- Heat Pump Model : ARUN100LT2, ARUN120LT2, ARUN140LT2, ARUN160LT2
- Cooling Only Model : ARUV120LT2(E), ARUV140LT2(E), ARUV160LT2(E)

* Before replacing INV control box or Fan motor PCB,
Please check Part Number.
There are two Part Number.

■ INV control box (Location Number : 649950A)

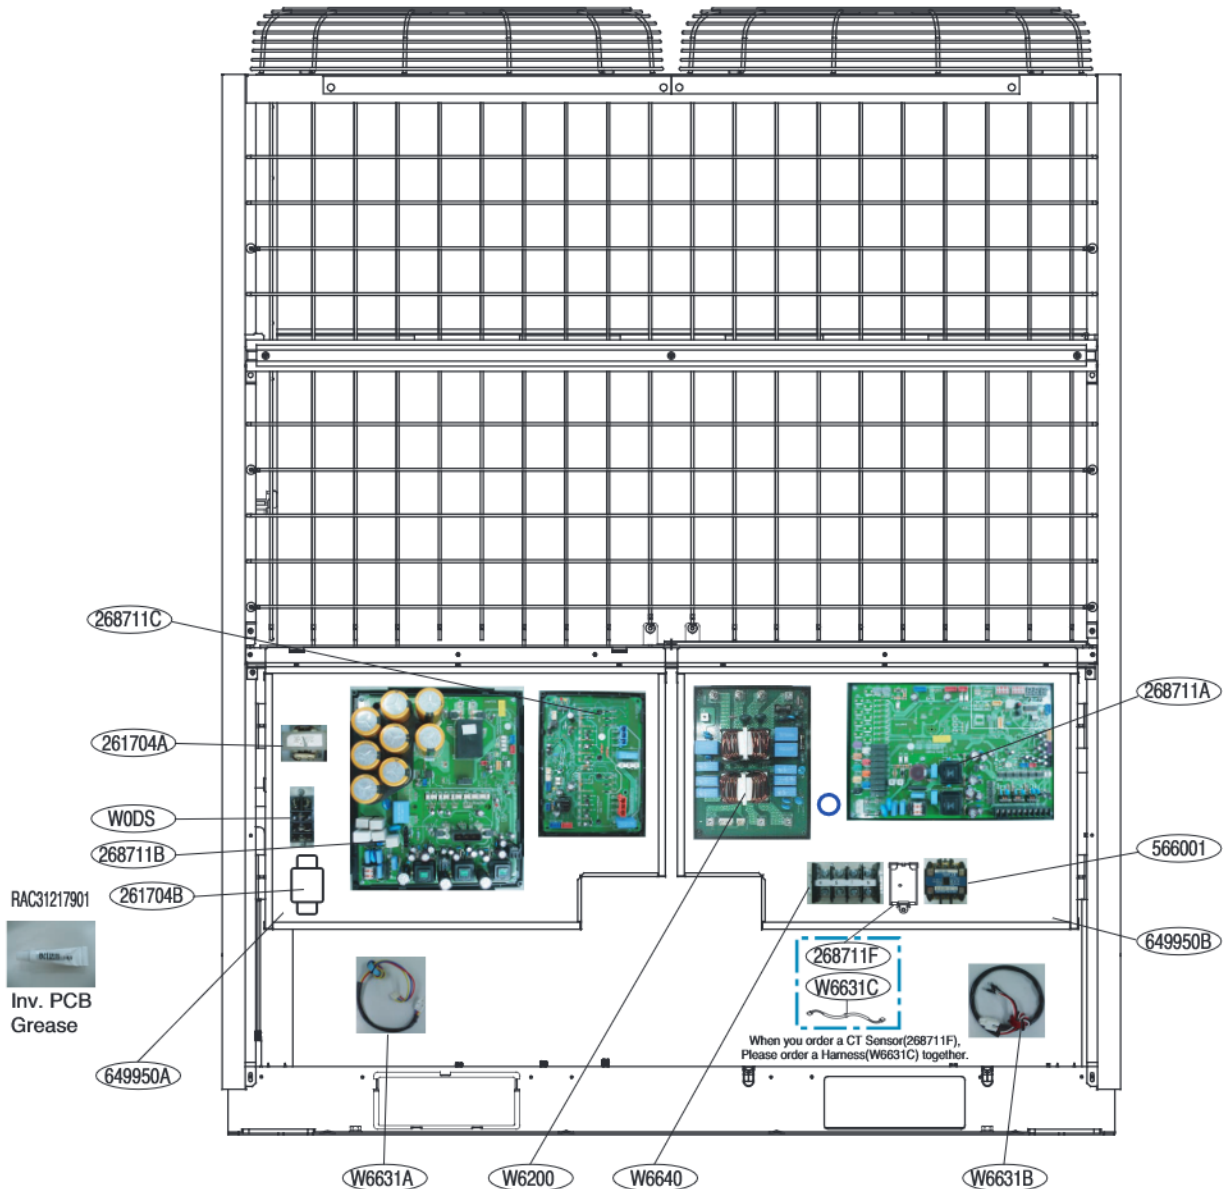
* After May , 2010 , Multi V Plus II use LG motor (New).

■ Fan motor (Location Number : 546810A,546810B)

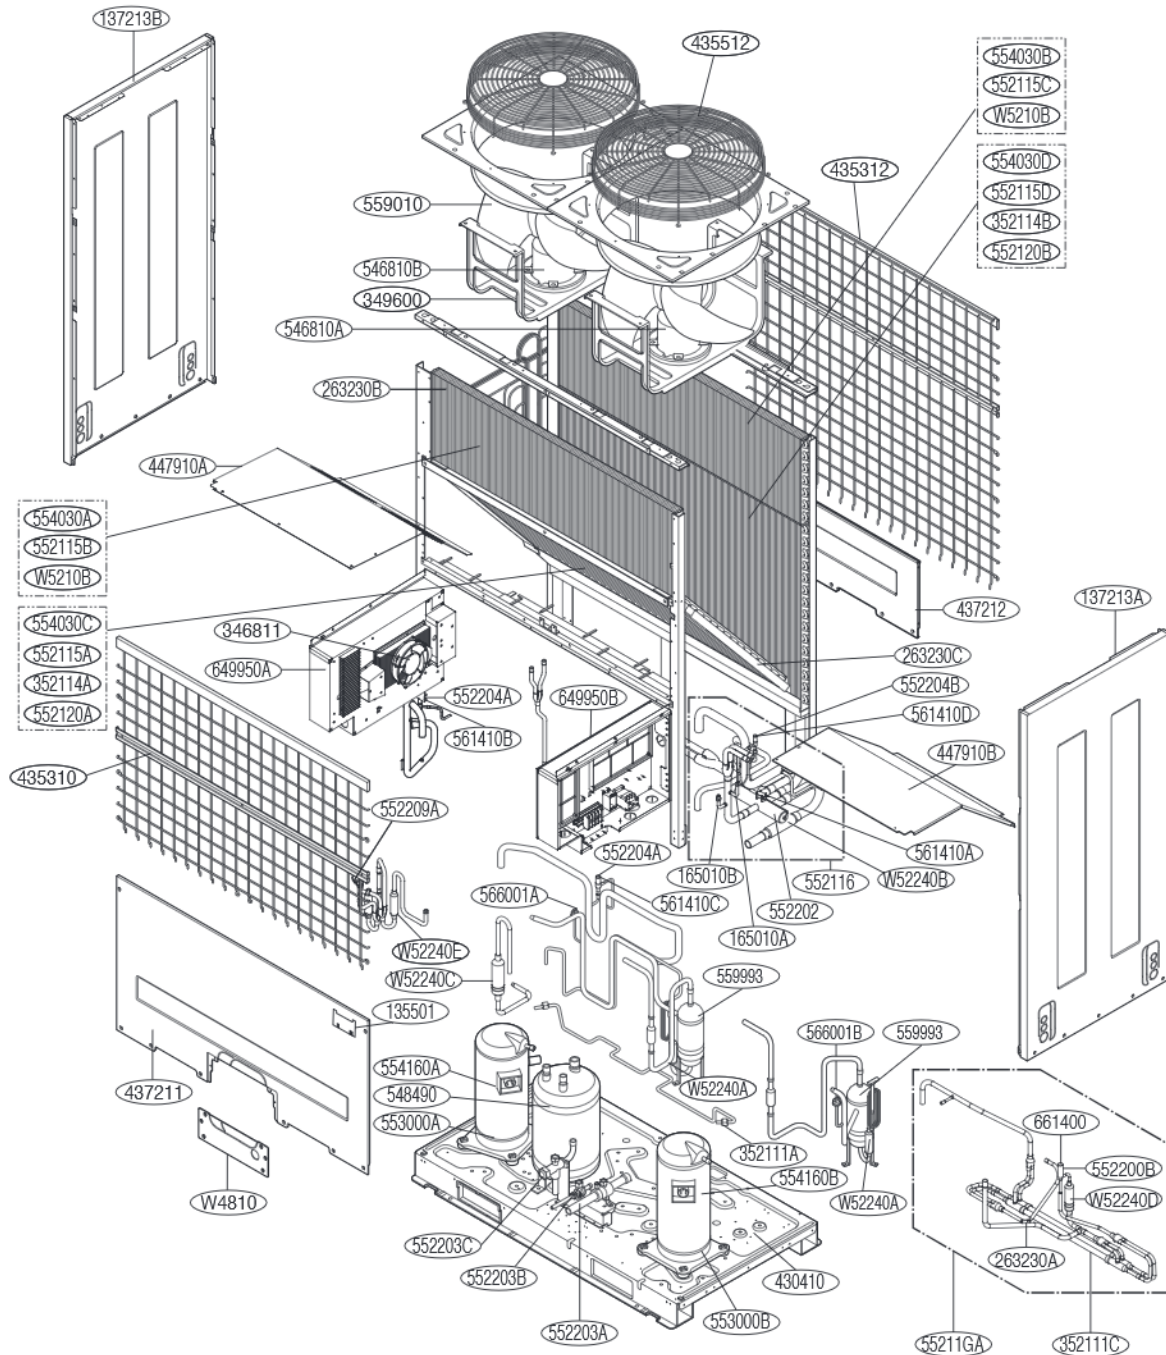
※ Before replacing fan motor, Please check fan motor maker.
 ※ Panasonic Motor (Part Number : EAU43475201) is the obsolete part. Please replace Panasonic Fan Motor with LG Fan Motor (Part Number : EAU36301603, EAU36301604) and LG Fan Motor PCB.
